Project	IEEE 802.16 Broadband Wireless Access Working Group http://ieee802.org/16 >			
Title	Optional outer-coded data mode for MBS			
Date Submitted	2008-09-11			
Source(s)	Ken Stanwood, Yoav Nebat, Lei Wang, Erik Colban, Yair Bourlas NextWave Broadband Inc.*	Voice: E-mail: kstanwood@nextwave.com; ynebat@nextwave.com; lwang@nextwave.com; ecolban@nextwave.com; ybourlas@nextwave.com

Optional outer-coded data mode for MBS

Figure 152a — Deterministic mapping of MBS outer-coded data to the MAC and PHY

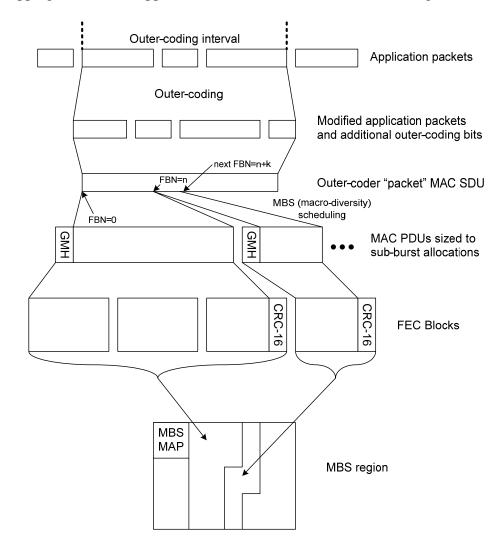
Since outer-coding can recover from missing the reception of an entire MAC PDU fragment of the outer-coder packet, unlike conventional fragmentation of SDUs into MAC PDUs, it is important to know which bytes were lost rather than merely that a particular fragment was lost. Moreover, this information must be sent as robustly as either the MBS_MAP or the outer-coded data. So, the fragmentation of outer-coder packets (MAC SDUs for the outer-coding function) into MAC PDUs shall not use the fragmentation or packing subheaders, but shall use a fragmentation byte number (FBN) in the MBS_OUTER_CODED_DATA_IE TLV in the MBS_MAP to indicate which byte of the outer-coder packet maps to the first byte of an allocation for the MCID. Additionally, to avoid dependence on the length field in the GMH to determine the number of padding bytes in the last sub-burst allocated for an outer-coder packet, at the end of the outer-coder interval the number of sub-burst padding bytes is included in the MBS_OUTER_CODED_DATA_IE TLV. This allows the MAC layer to use this information to strip the padding bytes before delivery to higher layers.

The process of mapping outer-coded application data to allocations is shown in Figure 152a.

Figure 152b — Application packets in a RS code block

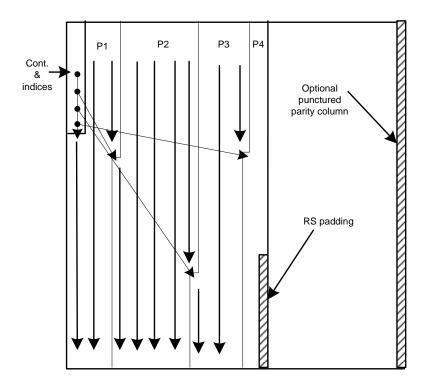
At the sender, the application layer packets are written into the Reed-Solomon code block vertically as shown in Figure 152b, effectively interleaving the packets across multiple Reed-Solomon codewords. They are preceded by a control block that aids in packet delineation without error propagation. The control block format is shown in Table 200a. RS padding bytes are added to the last few bytes of the data section of the table if necessary to fill the data section of the table. These shall have the value 0x00 and shall not be transmitted over the air.
